THE CITY OF DURHAM TRUST

2 January 2022

DM/21/03574/OUT Land at Sniperley Park west of the A167 and north and south of the B6532 Durham: Demolition of existing buildings adjacent to B6532 and outline planning permission (all matters reserved except access) for a maximum of 1,550 dwellings (Use Class C3), a local Centre (use classes E and F2), public house (use class sui generis) and primary school (use class F1), associated infrastructure and landscaping.

From p. 410 of Co. Durham Land LLP Matter 5 Statement (County Durham Plan EiP) showing additional link roads in blue.

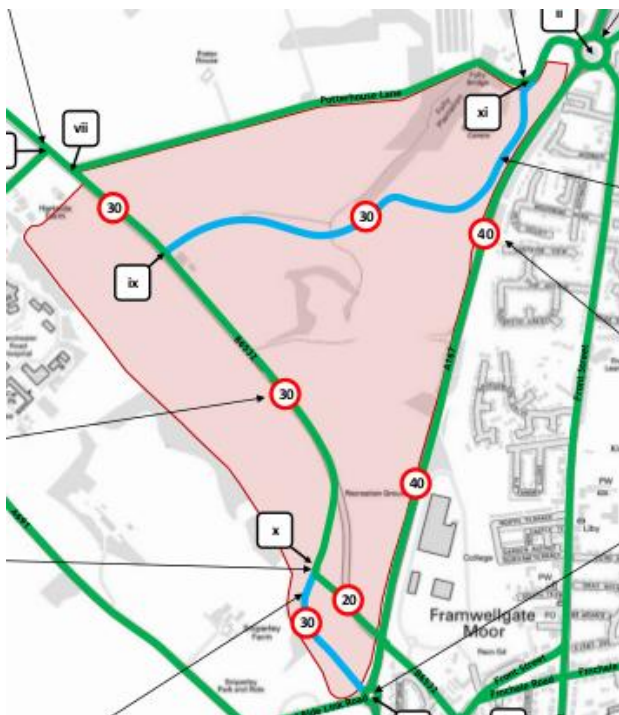
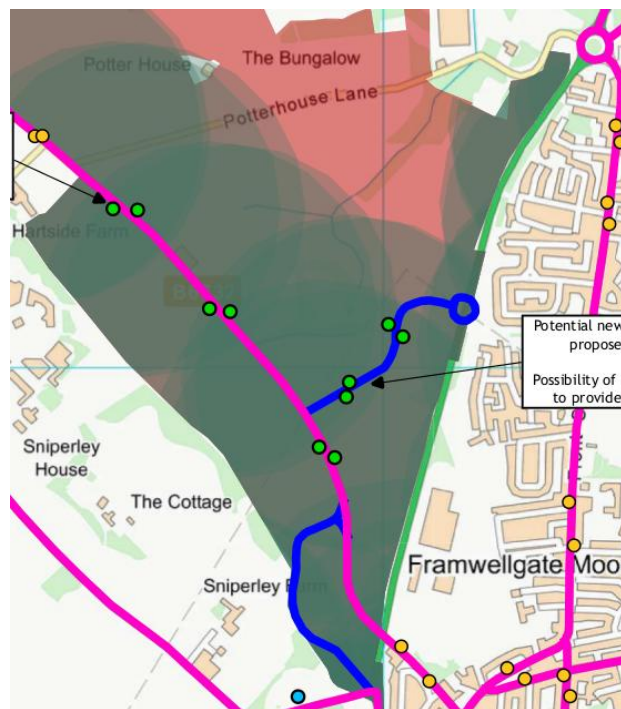
In the applicant's evidence submitted to the Examination in Public of the County Durham Plan there was a proposed internal road layout which facilitated bus access, accompanied by a proposal for an extended Go North-East 20A bus from central Durham via the B6532, continuing through the site to the Pity Me roundabout and the Arnison Centre. The road layout proposed in 2019 brought a much larger proportion of the site within 400m of a bus stop compared to the layout outlined in this application.

The draft masterplan prepared by the County Council includes an additional link between the B6532 and the A691 which could further improve bus penetration of the site. The separate applications from Bellway and County Durham Land LLP have no such bus link. This underlines the need for a masterplan for the whole site which can optimise the bus accessibility.
